USB4 1.0 ENGINEERING CHANGE NOTICE FORM

Title: Bit Banging Interface Definition
Applied to: USB4 Specification Versions 1.0

Adds more details regarding the TBT3-Compatibility bit banging mechanism in Chapter 13.

The waveform below shows an example of how the FL_SK, FL_CS, FL_DI, and FL_DO are used:

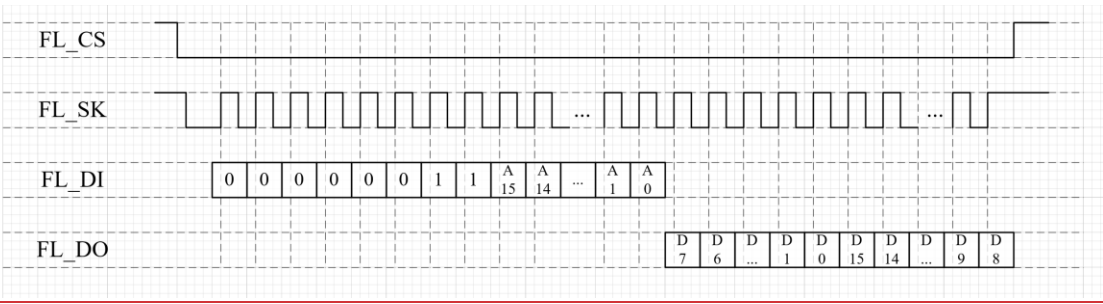
When using the bit banging interface, a Connection Manager sends the following bytes on FL DI:

- Byte 1 is a read command (03h)*
- Byte 2 is bits [15:8] of the address to be read*
- Byte 3 is bits [7:0] of the address to be read*

The Connection Manager then reads the resulting data from the FL DO bit as follows:

- Byte 1 is bits [7:0] of the read data*
- Byte 2 is bits [15:8] of the read data (if present)*

Note that all bytes are sent and received with the most significant bit first.
